**Town of Rotterdam
Planning Commission
October 4, 2022**

DPW Comments
October 4, 2022

Re: *Site Plan Application – Proposed Key Bank*
1703 Altamont Avenue, Town of Rotterdam
CTMA Project No. 22.2224

Re: Site Plan Application - Proposed Key Bank
1703 Altamont Avenue, Town of Rotterdam
CTMA Project No. 22.2224
Response to Comments

1703 ALTAMONT AVENUE
 NE 1 DRVN.
 UTILITY PLAN
 TAX PACT. NO. 94-1415 I
 TOWN OF ROTTENDALE
 COUNTY OF SCHENECTADY, STATE OF NEW YORK.
 CA120
 10/17/11

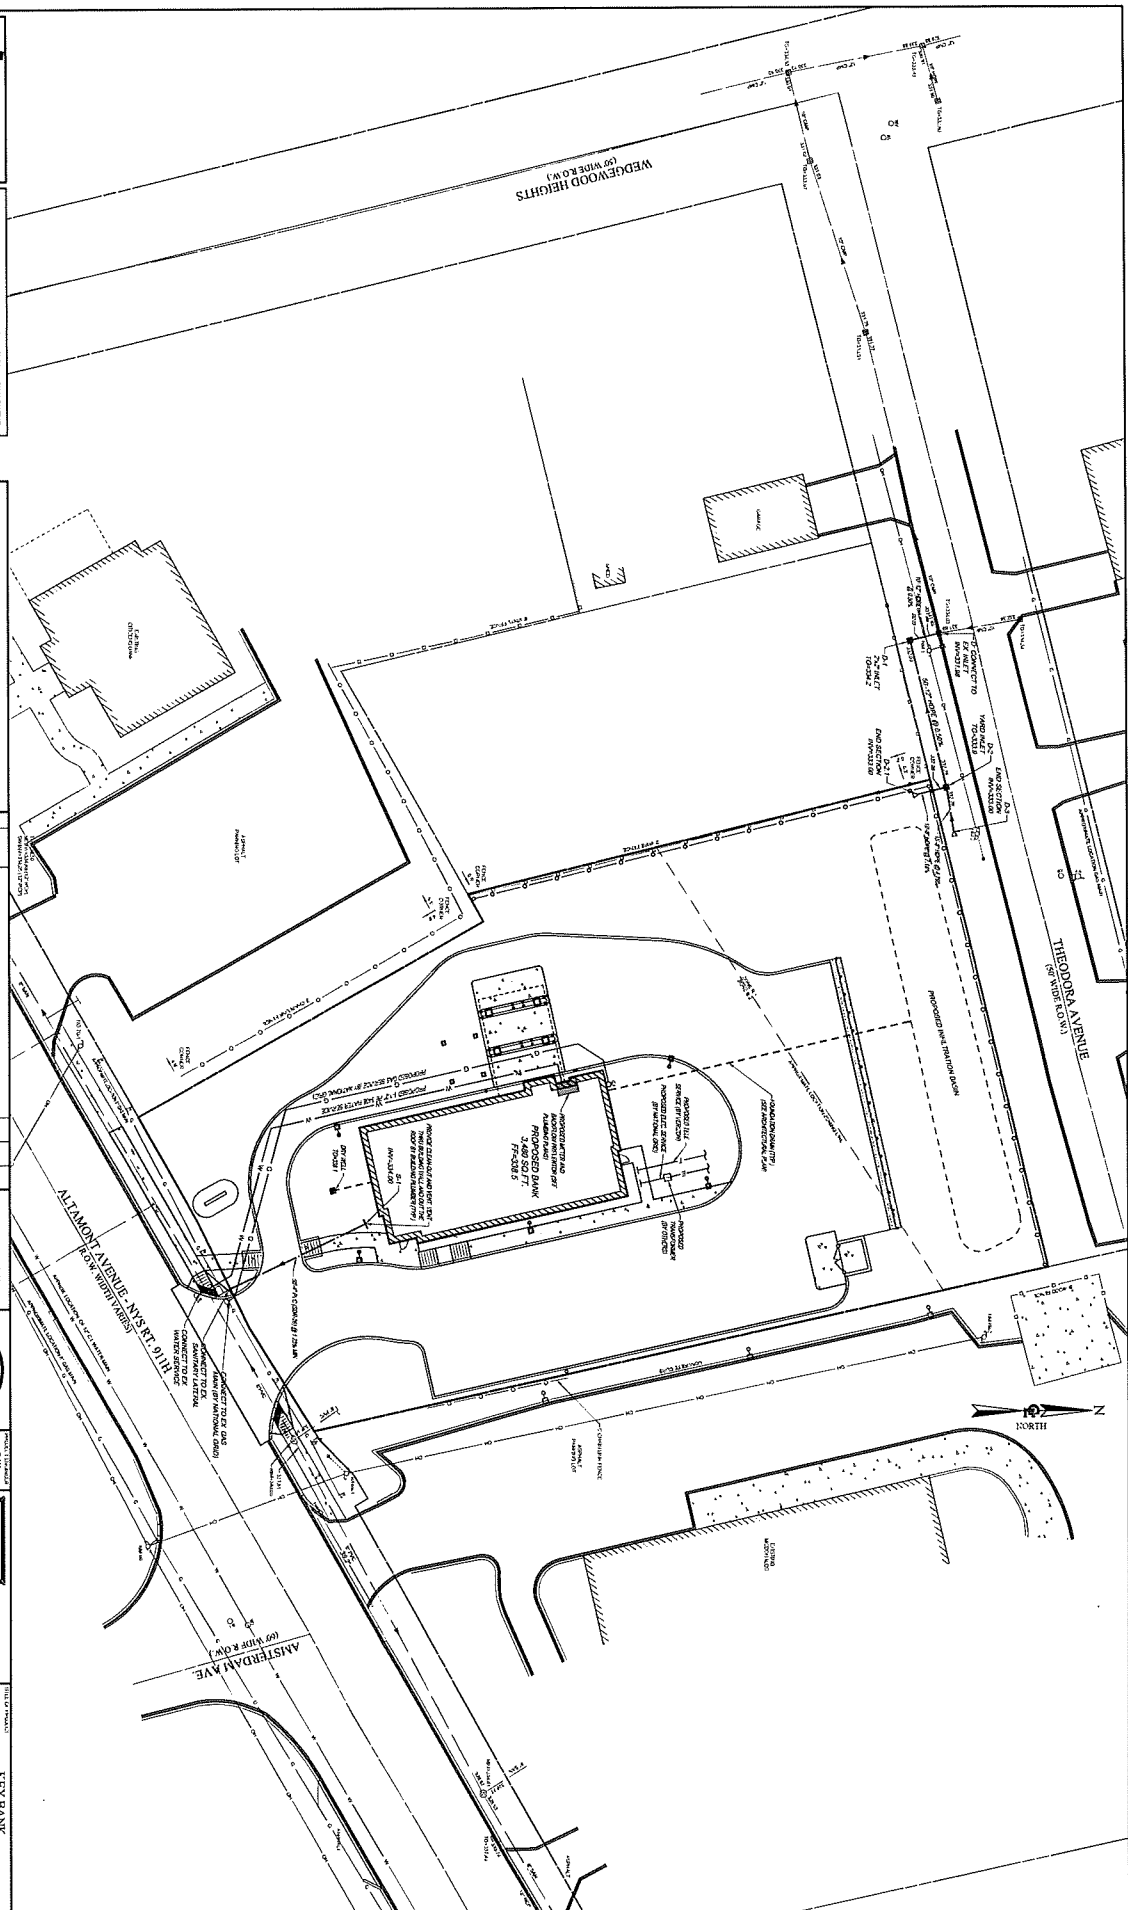
10. *We offer the following comments regarding Sheet "CA120" Utility Plan:*

- a. The applicant shall provide documentation that the proposed water and sanitary sewer and storm sewer connections have been coordinated with the appropriate Town Staff.*

- b. The proposed storm drainage pipes at the rear of the site along Theodora Avenue have minimal coverage. The design engineer shall provide documentation that the proposed pipes are designed to handle the minimal depths shown.*

Noted. Plans will be updated per any DPW comments received. Per conversation with Tammy from Town DPW, they concur with methods currently proposed.

See note #6 under "General Notes" on Drawing GA002.

EXTERIOR ELEVATIONS

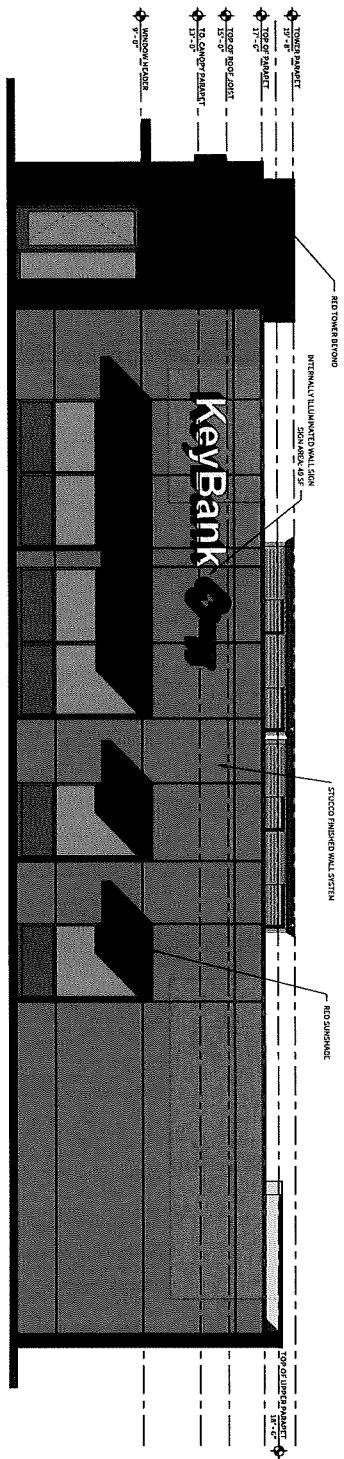
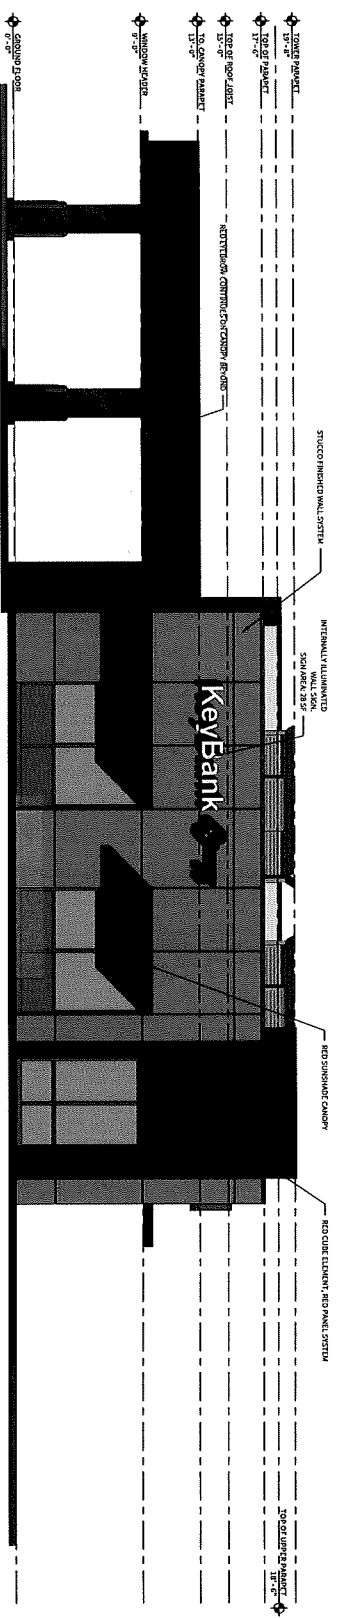
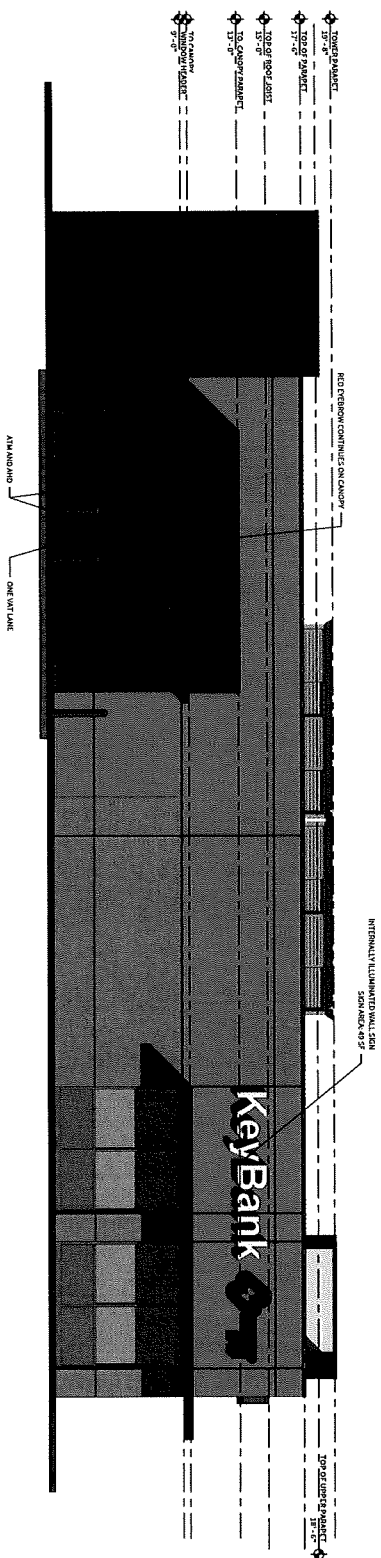
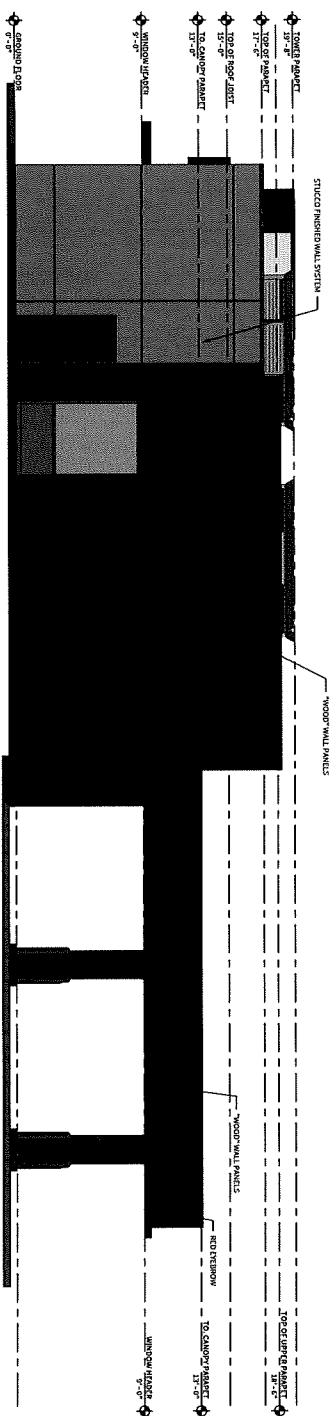
10. Add note to plan: “Building design shall be in substantial conformance to the proposed Exterior Elevations know as sheets SD1-SD4 entitled Rotterdam Branch Keybank National Association dated April 26, 2022 as prepared by HSB Architects & Engineers.”
